## **Proposal for amendments to UN Regulation No. 46 (Devices for indirect vision)**

The text reproduced below was prepared by the expert from the International Organization of Motor Vehicle Manufacturers (OICA) to introduce provisions adapted to centre-steered vehicles of category M<sub>2</sub>, M<sub>3</sub>, N<sub>2</sub>, N<sub>3</sub>. The modifications to the current text of the regulation are marked in bold for new and strikethrough for deleted characters.

**Figure 9.1**

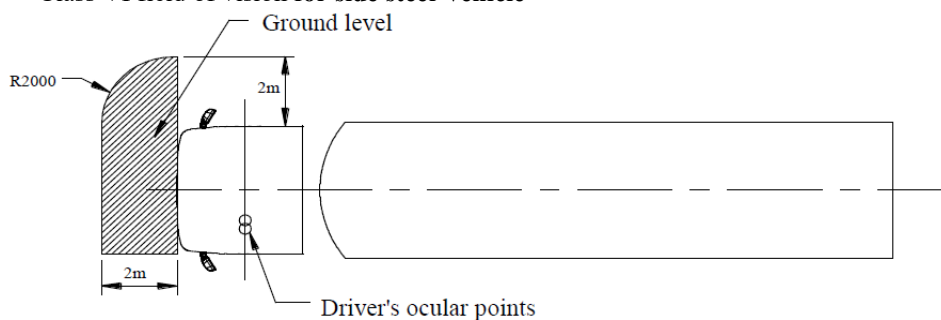
Figure 9.1., amend to read:

Class VI field of vision **for side steer vehicle**

- 15.2.4.6.1. The field of vision shall be such that the driver can see at least a flat horizontal portion of the road, which is **for side steer vehicles** bounded by:
- (a) A transverse vertical plane through the outermost point of the front of the vehicle;
  - (b) A transverse vertical plane 2,000 mm in front of the plane defined in (a);
  - (c) A longitudinal vertical plane parallel to the longitudinal vertical median plane going through the outermost side of the vehicle at the driver's side; ~~and~~
  - (d) A longitudinal vertical plane parallel to the longitudinal vertical median plane 2,000 mm outside the outermost side of the vehicle opposite to the driver's side; ~~and~~
  - (e) ~~The the~~ front of this field of vision opposite to the driver's side may be rounded off with a radius of 2,000 mm (see Figure ~~9 9.1~~).

**Figure 9.2**

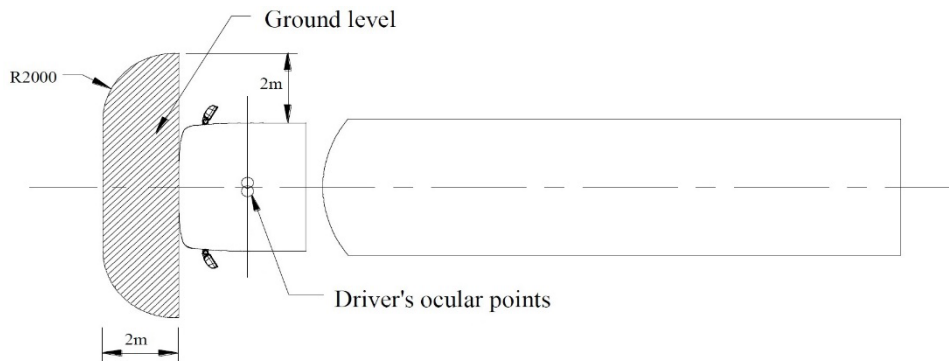
Insert a new figure 9.2, to read:

Class VI field of vision **for center steer vehicle**

**The field of vision shall be such that the driver can see at least a flat horizontal portion of the road, which is for center steer vehicles bounded by:**

- (f) A transverse vertical plane through the outermost point of the front of the vehicle;**
- (g) A transverse vertical plane 2,000 mm in front of the plane defined in (a);**
- (h) A longitudinal vertical plane parallel to the longitudinal vertical median plane 2,000 mm outside the outermost side of both sides of the vehicle; and**
- (i) the front of this field of vision on both sides may be rounded off with a radius of 2,000 mm (see Figure 9.2).**

Since the driver is sitting the middle of the vehicle, the same fields of view on both sides of the vehicle are needed for usage in left-hand- and right-hand traffic. Therefore, the class VI field of view has been mirrored over the center of the vehicle for center steer vehicles.

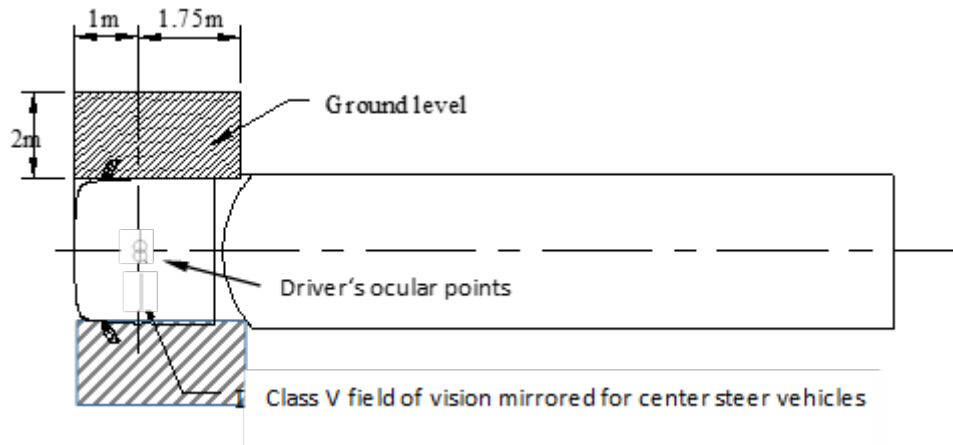
Since the driver is sitting on the longitudinal axis of the vehicle, further away from the side window (compared to the driver’s side of a side steer vehicle), the direct vision next to the vehicle is more obstructed. The driver cannot see straight down to the road on either side on center steer vehicles. Therefore, the indirect vision requirement class V is necessary on both sides of the vehicle to provide adequate vision.

**“15.2.1.1.1. The fields of vision prescribed in paragraph 15.2.4. below shall be obtained from the minimum number of mandatory mirrors or camera-monitor devices set out in the following table.**

Figure 1 - Viewing angles and distances for UN/ECE-R46 class II:

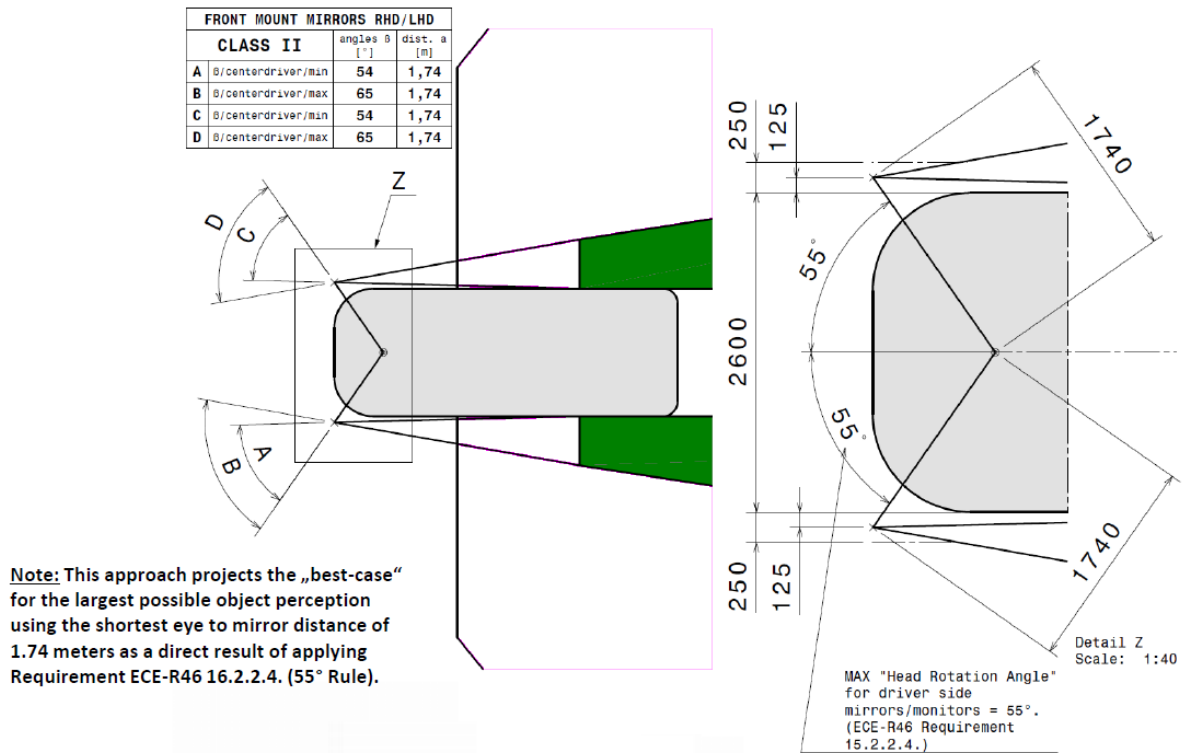
- The viewing distances  $a_{\text{centerdriver}}$  are calculated by trigonometric projection using the rules above.
- The relevant viewing angles  $\beta_{\text{centerdriver}/\text{min}}$  and  $\beta_{\text{centerdriver}/\text{max}}$  are calculated by trigonometric projection performed in a simplified horizontal plane where the required FOV provides the front most aim points as described in the ISO 16505:2019 Standard ANNEX B.3.1 Figure B.18

- The results of these projections shown in the Tables below (see Figures 1 and 2), and the minimum allowed curvature radii of  $r=1200\text{mm}$  for CLASS II and  $r=300\text{mm}$  for CLASS IV, are the input values used to calculate the Center-Steer magnification factors.

- “16.1.3.1.2. Magnification factor for center steer vehicles of categories M<sub>2</sub>, M<sub>3</sub>, N<sub>2</sub>, N<sub>3</sub>**  
**The minimum and the average magnification factors of the CMS, in both horizontal and vertical directions shall not be lower than the minimum average magnification factor indicated below.**  
**The minimum magnification factor shall not be less than:**
- (a) for Class II (driver center): 0.22;
  - (b) for Class IV (driver center): 0.043.
- The average magnification factor shall not be less than:**
- (c) for Class II (driver center): 0.23;
  - (d) for Class IV (driver center): 0.068.”
